Re: PL/2026/04254 - OBJECTION

We object to Application PL/2026/04254, which seeks retrospective permission to construct a hard-surfaced track between the access and the 'permitted building', and respectfully request that the application be refused or, in the alternative, deferred pending consideration of the wider retrospective position on the site.

Fig 3: Block Plan: PL/2026/04254

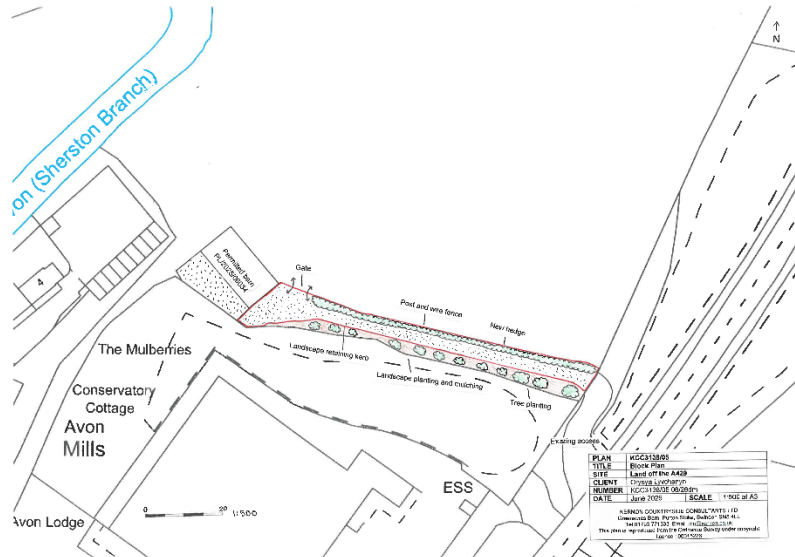
The Block Plan, Fig. 3 below, indicates that the increased area of proposed hardstanding in front of the barn extends across the frontage formed by an unauthorised retaining wall. If the proposed trackway is approved, other unauthorised works that have not yet been included in any retrospective planning application would in effect be incorporated.

The Block Plan shows a significant additional solidified area to the west of the unauthorised building work between two unauthorised retaining walls. It extends to the boundary of the field. There is no explanation or justification for this construction in this application and no grounds to consider it as part of this application other than to confirm it is unauthorised work that is not part of this application, or as a reason for the rejection of the application.

This major omission makes the application incomplete. The applicant should be required to show the proposed replacement tree locations on the Block Plan. For clarity, the trees already shown have been planted and are not the conditioned replacement trees.

The only reference to a track is in the Block Plan labelled Rev F, which indicates an ‘*informal access to the building*’. This informal access is shown by hashed lines and links to the south-eastern side of the building. There is no reference to a requirement for a solid track during the construction phase or for continuing operational purposes.

The approved plan has the vehicle access at the **north** elevation – the opposite end to where the track reaches. See *Fig 2 below*.

There is therefore a major inconsistency between the block layout and the approved floor and elevations plan in terms of orientation. It appears from the information provided that the entrance doors would be approximately 3 metres above the ground level when you take the hillside location/or the current unauthorised works into account and if we presume that the building is proposed to be on top of what has already been built. As a North entrance does not appear to be feasible it is presumed that the entrance would be located on the South East elevation. This is the exact opposite of the previously submitted and approved plan. Currently, the track in the Block Plan in PL/2026/04254 (Fig 3 below) is not shown connecting to an entrance that is part of the approved plan.
